REGIONAL TRANSIT ISSUE PAPER

Subject: Approving and Filing the CEQA Addendum for the South Sacramento Corridor Phase 2 Project

Addendum

69 kV Transmission Line Realignment and Multi-Use Bridge & Pathway Lighting

Figure 2-1. Wetland Delineation

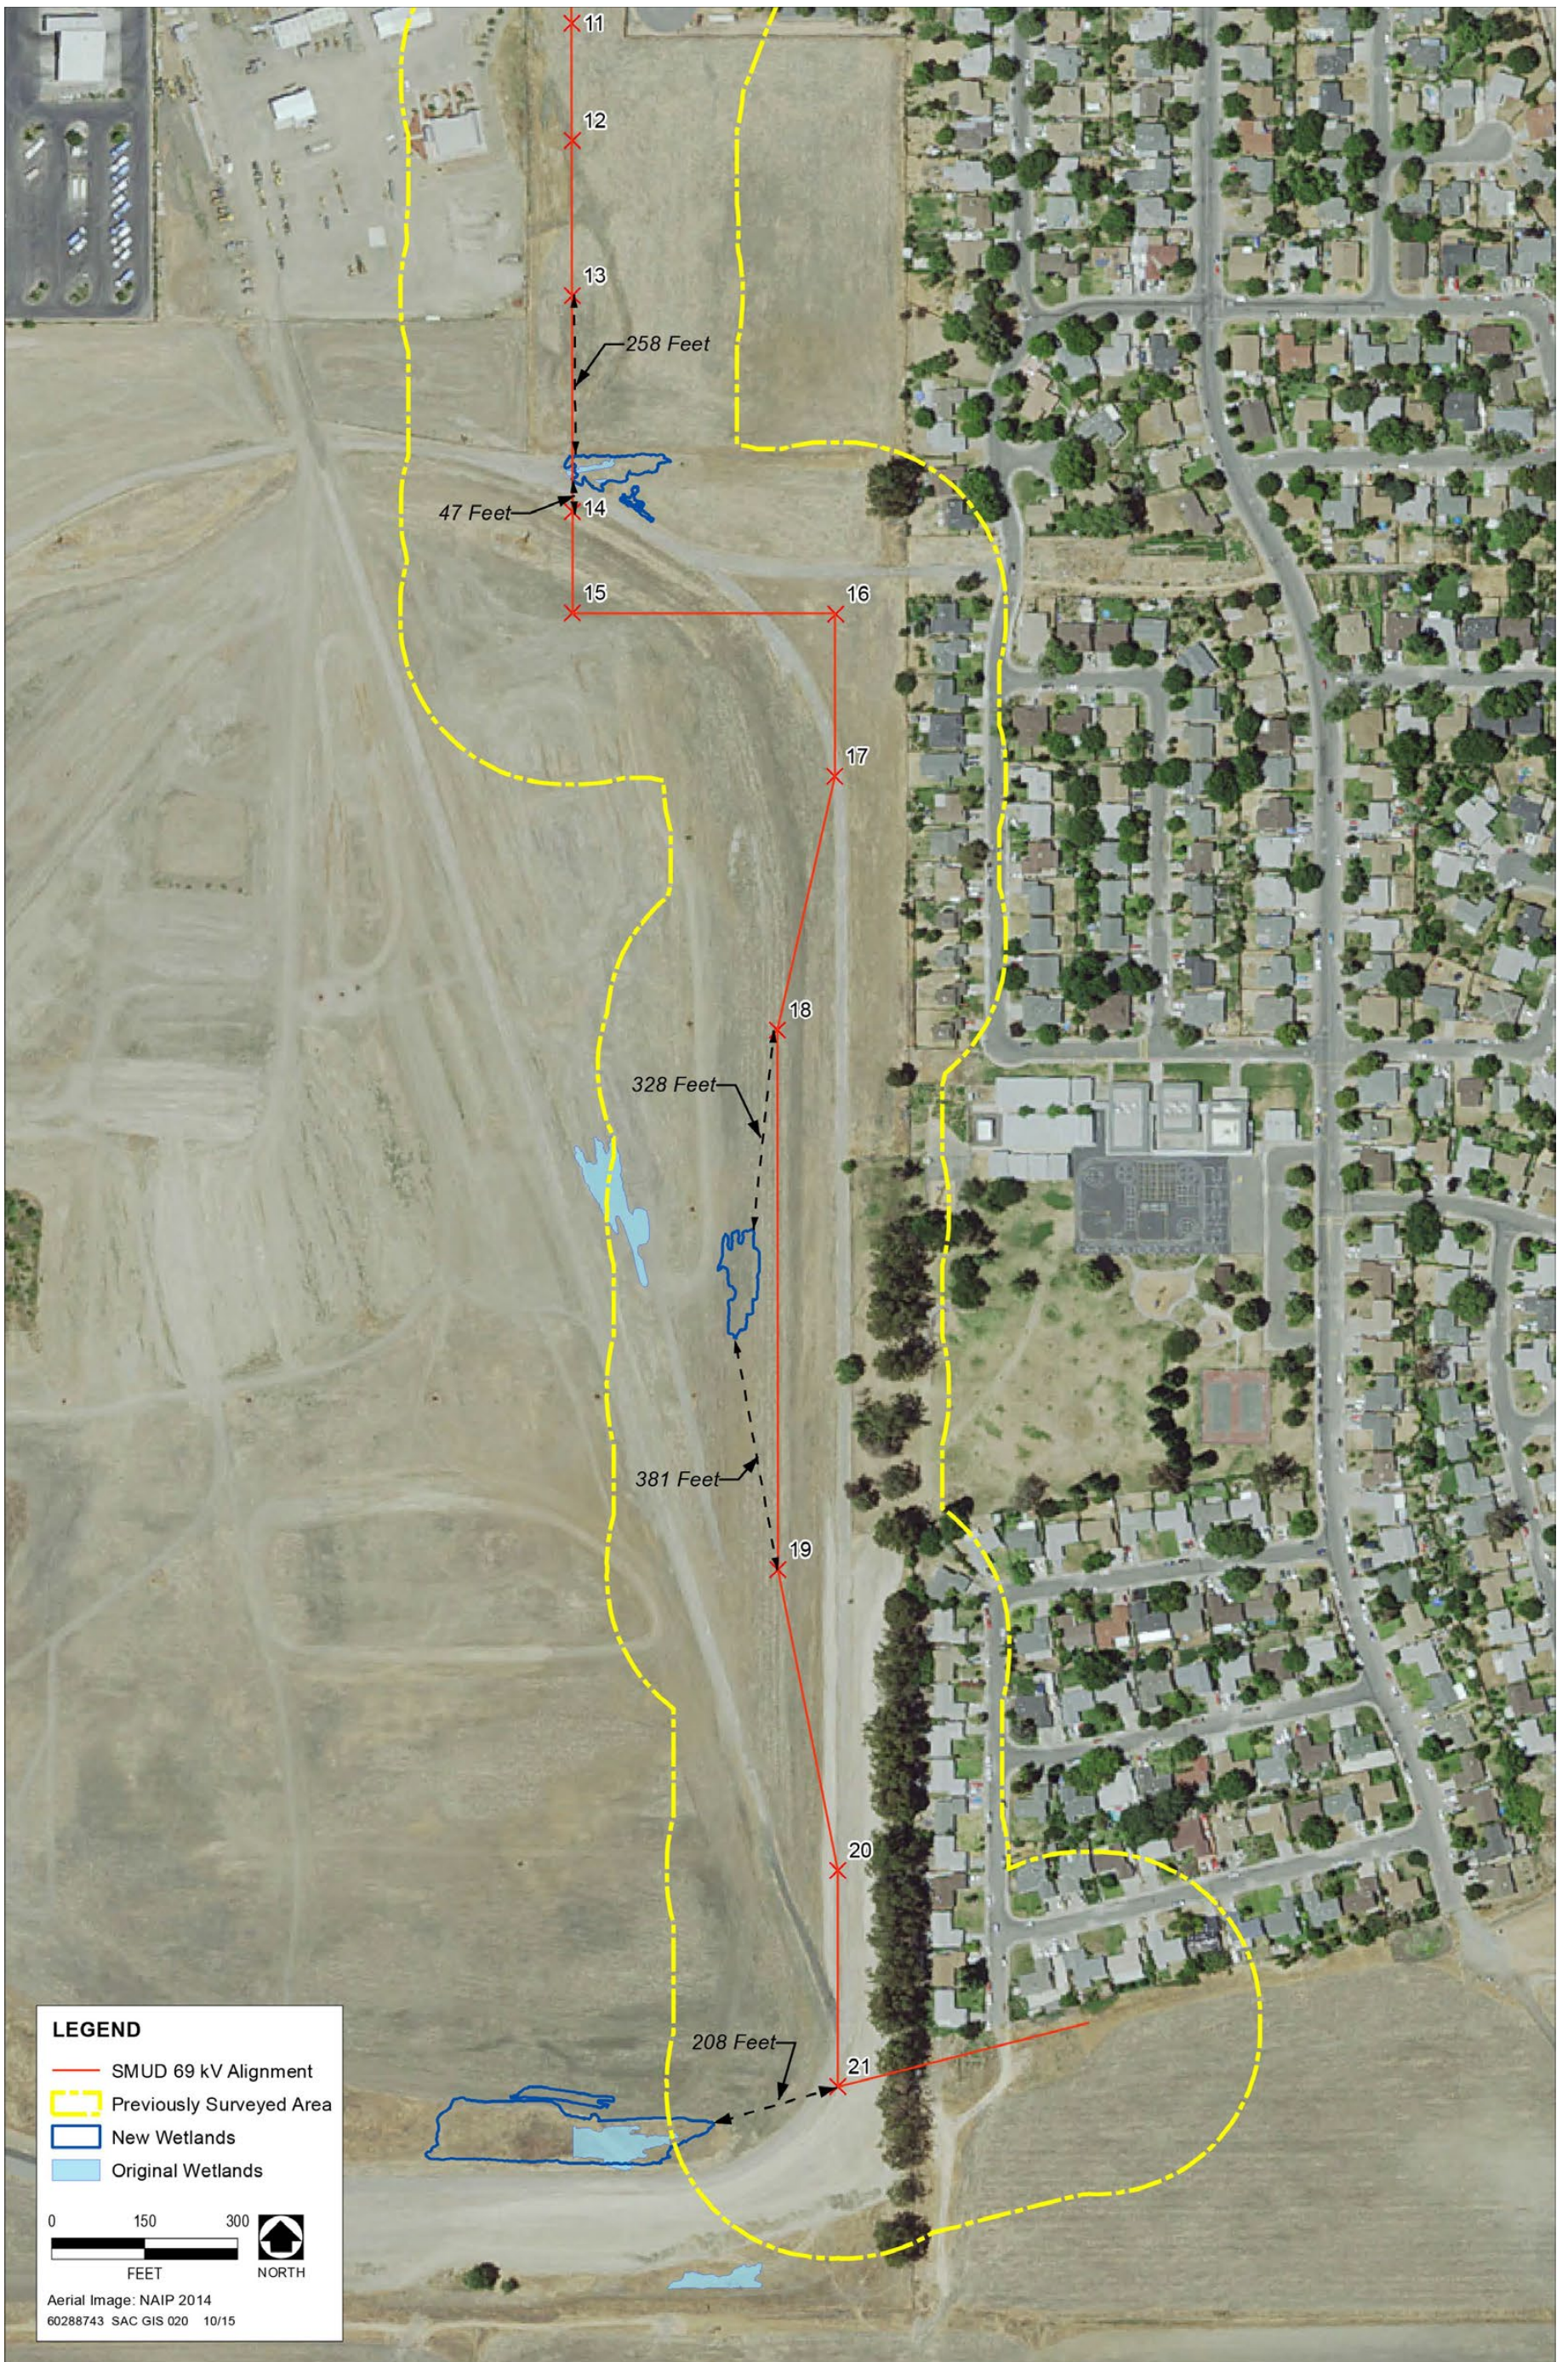
One of the previously characterized wetland features addressed in the 2013 IS/MND was determined to be larger than mapped in 2013 (see Figure 2-1). Based on the 2015 delineation, this wetland feature is located approximately 200 feet from pole 21. Although within the 250-foot buffer, the proposed location of pole 21 is hydrologically separated from the vernal pool by an existing paved roadway that would also serve as the access road. Therefore, this wetland feature would not be directly affected.

One new wetland feature was identified within the study area for the proposed realignment (see Figure 2-1). The project realignment was designed to maintain a distance greater than 250 feet to this vernal pool feature. To accommodate this separation, an approximately 860-foot swing span would occur between pole 18 and pole 19 that would avoid sensitive vernal pool wetland resources. This new swing span would replace the 740-foot segment swing span alignment between tubular steel poles (TSPs) 16 and 17 described in the 2013 IS/MND. Best Management Practices associated with the Storm Water Pollution Prevention Plan, as adopted in the 2013 IS/MND would protect this feature from indirect impacts that could be caused by siltation or inadvertent incursion into the vernal pool area. In addition, all work in the area would be conducted during the dry season, per the U.S. Fish and Wildlife Service (USFWS) conditions stipulated during previous SSCP2 consultations and SMUD technical assistance direction.
